HARTING Product Change Notification

PCN/17/026/PM+MD

Product range: DC2 / Circular connectors

Title: M12 Slim Design shielding element improvement - External

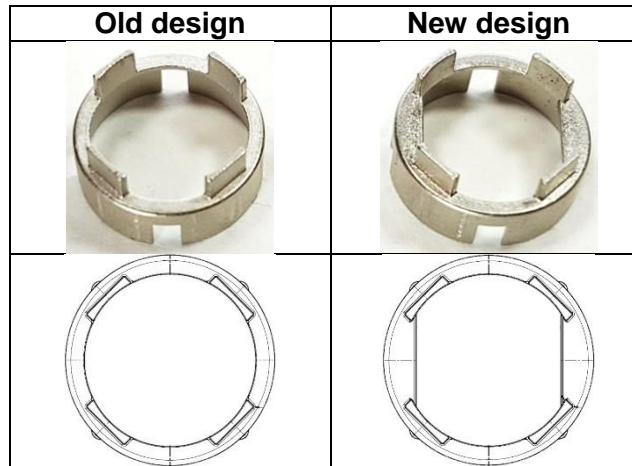
The inner contour of the shielding element of M12 Slim Design straight connectors has been changed from round shape to double D shape. This improvement secures the proper assembly and avoids the displacement of the contact carrier in assembled condition.
